Re: **Escondido North Subdivision (Amended)**

MDP # 868-A

The City Staff Development Review Committee has reviewed Escondido North Subdivision Master Development Plan **MDP # 868-A** previously known as Sonoma Subdivision MDP. Please find enclosed a signed copy for your files. Your plan was approved for acceptance, however please note the following:

ESCONDIDO NORTH SUBD. MASTER DEVELOPMENT PLAN MDP #868A	DESIGNED BY:	HJ
	DRAWN BY:	HJ
	APPROVED BY:	CB
PREPARED BY:	DATE:	06-2005
BAIN MEDINA BAIN, INC. ENGINEERS & SURVEYORS 7073 San Pedro San Antonio, Texas 78216 210/494-7223	JOB NO.:	C-0967
	SHEET	1
	OF	1

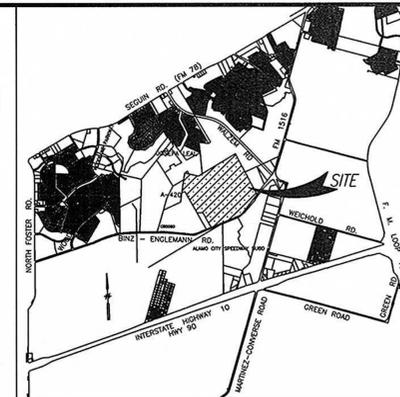
- The developer shall be responsible for providing a right-turn deceleration lane (295' with

taper) as well as left turn lanes (200' storage and 100' taper) for Binz-Engleman at Texas Palm Drive (entrance), as it relates to the submitted TIA traffic counts (Unified Development Code (UDC) - 35-502 (a)(7), subsection C.

- The construction of Unit-4 will overburden Bandera Path with over 1,000 vpd. Unit-7 shall be submitted prior to, or in conjunction with Unit-4, with the secondary entrance across the CPS easement.
- It should be understood that this is a general review of a conceptual plan not an in-depth review of internal and external traffic flow, or streets and drainage plans. The internal street network shall be planned in order to provide safe and efficient movement of traffic to and from, within and past, the proposed development, while minimizing the impact to non-site trips. All technical requirements of the Unified Development Code will be complied with at the time of platting.

- The 268 acres is proposed to consist of 696 single family residential lots and 4.88 acres of retail use. This mixed use development is estimated to generate 8,621 average daily trips. These trips will be distributed through a collector roadway, aligned with Texas Palm Drive at Binz Engleman Road, which will extend to the north-most part of the subdivision.
- The following improvements will be provided by the developer prior to completion of the Escondido North Subdivision:
 1. An eastbound left turn and a westbound right turn deceleration lane on Binz Engleman at Texas Palm.
 2. Secondary access to the proposed collector roadway will be required prior to approval of any phase exceeding 125 lots.
